Product Change Notification

1. ECN #: 268434

- MPC - MPC

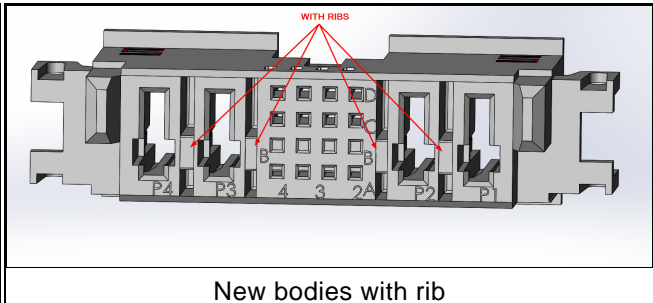
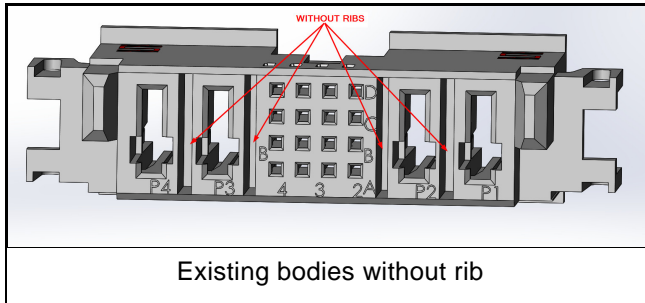
A rib is being added to the void core area on the mating side of the part.

The new bodies will contain a new rib inside of the void core area.
